PIT5657A Loose Shifter Lever / Poor Shift Actuation from Shift Lever / Shift to Park Message / Dead Battery

Product Investigation Review Required

Brand:	Model:	Model Years:	VIN:		Engine:	Transmissions:
			from	to		
Chevrolet	Silverado 1500 (New Model)	2019	All	All	All	All
GMC	Sierra 1500 (New Model)	2019	All	All	All	All

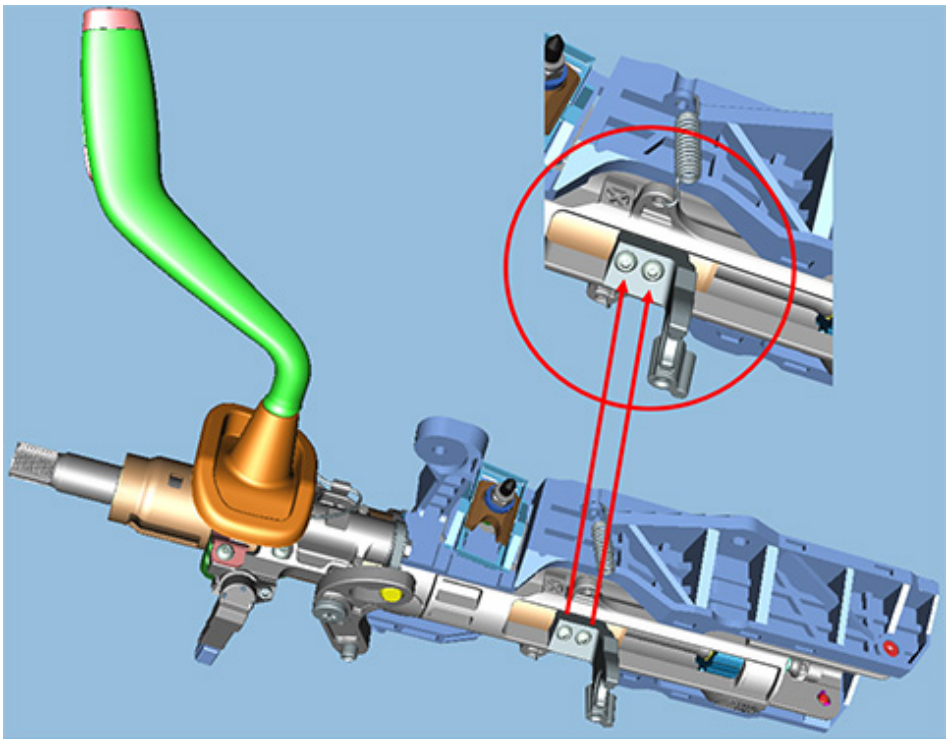
Involved Region or Country	North America
Condition	Some customers may comment of a loose shifter lever, poor shift actuation from the shift handle, and/or unable to shift to park. If the shifter will not go into park, the ignition will not turn off completely, which could cause a dead battery. Also, a "Shift to Park" message will be displayed on the DIC.
Cause	This concern could be caused by the shift cable bracket attaching bolts being loose, see picture below.

Note: Do NOT tighten these bolts, they are not serviceable.

Inspect the shift cable bracket attaching bolts for being loose. If the bolts are found to be loose, replace the steering column assembly. Do NOT tighten or replace these bolts, they are not serviceable.
